MARK	DATE	DESCRIPTIONS	BY	CH'D	CCO#
1	04/02/07	CROSSBEAM KINK	GB	DT	38

SAN FRANCISCO OAKLAND BAY BRIDGE
EAST SPAN SEISMIC SAFETY PROJECT
SELF-ANCHORED SUSPENSION BRIDGE
(SUPERSTRUCTURE & TOWER)

TYPICAL GIRDER DETAILS NO. 15

CROSSBEAM ACCESS DETAILS NO. 4

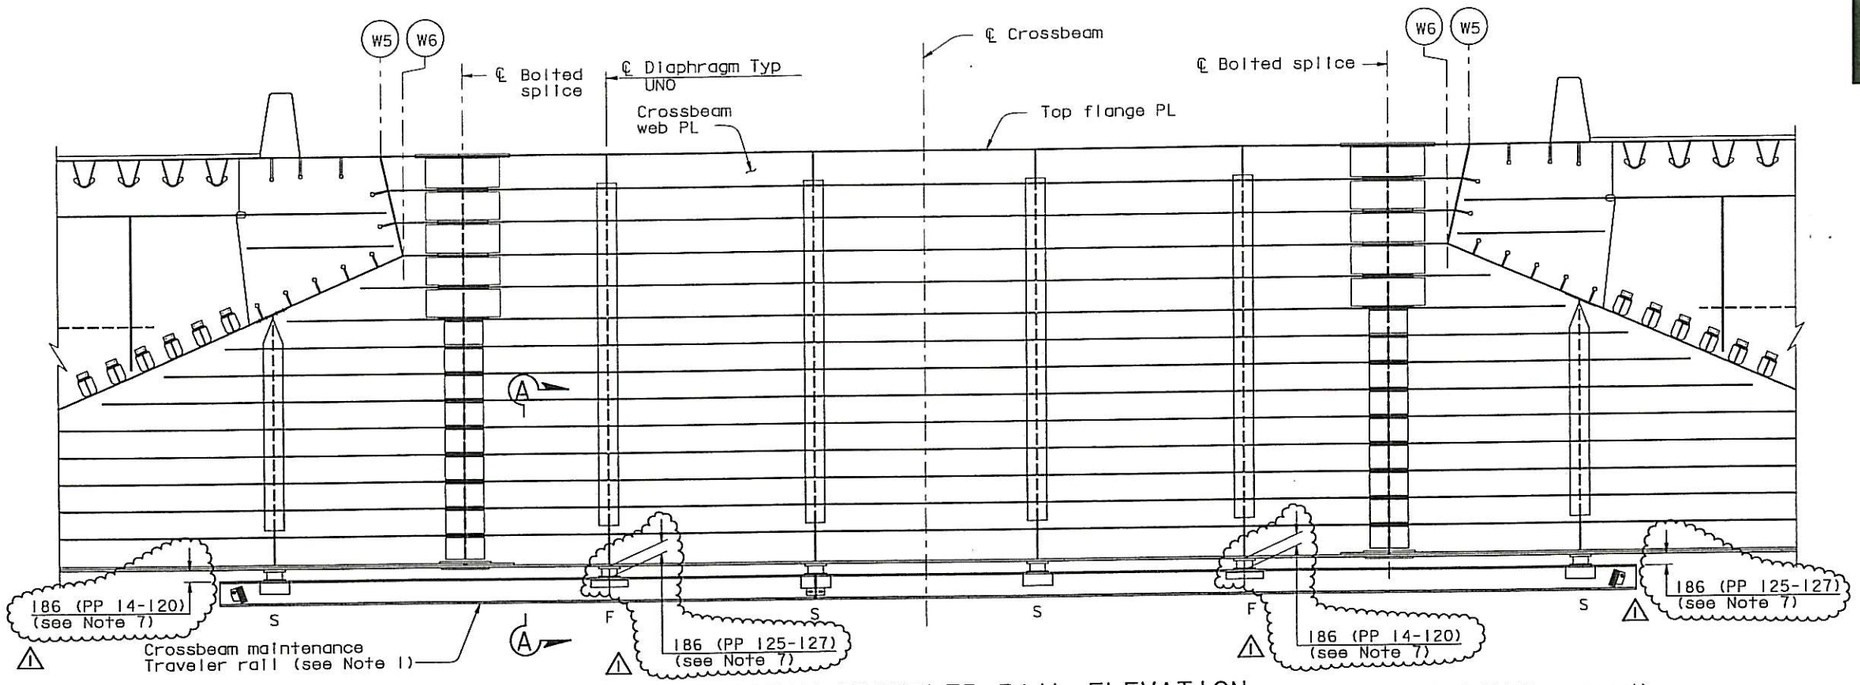
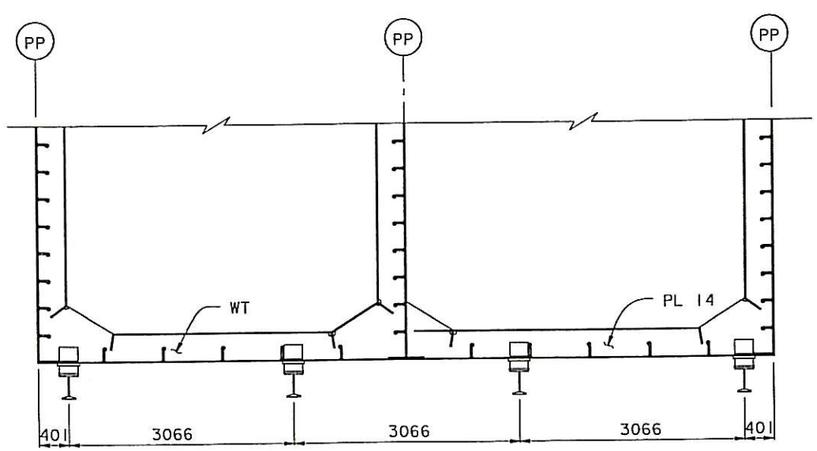
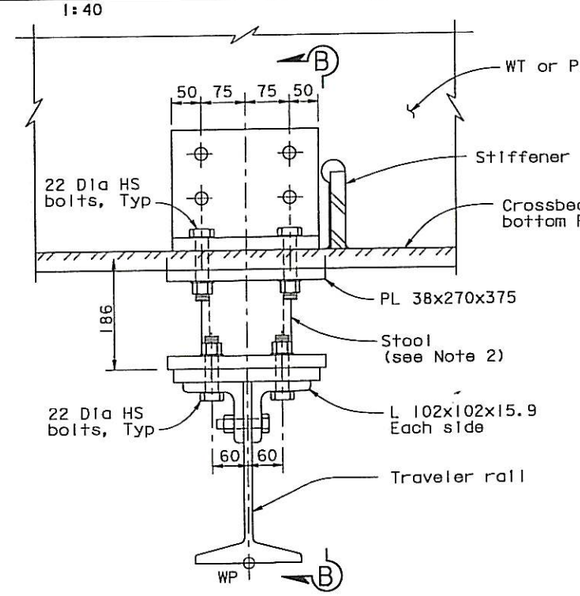
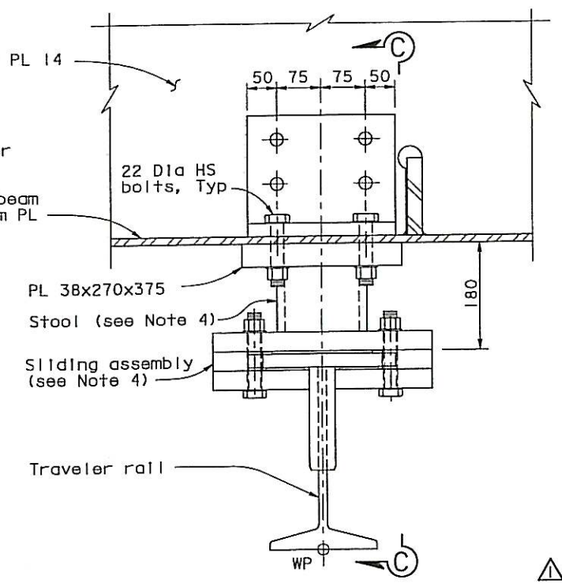
MARK	DATE	DESCRIPTIONS	BY	CH'D	CCO#
1	04/02/07	CROSSBEAM KINK	MN	GB	38

1. For traveler rail details, see "Traveler Rail Details No. 1" and "Traveler Rail Details No. 2" sheets.
2. For additional details not shown at fixed support, see "Traveler Rail Details No. 5" sheet.
3. For Section B-B, see Section A-A on "Traveler Rail Details No. 5" sheet.
4. For additional details not shown at sliding support, see "Traveler Rail Details No. 7" sheet.
5. For Section C-C, see Section A-A on "Traveler Rail Details No. 7" sheet.
6. The bolt sizes shown correspond to US Standard bolt sizes.
7. The traveler rail shall be straight. For crossbeams PP 14-28 and PP 125-127 the rail clearance shall vary between the specified supports.
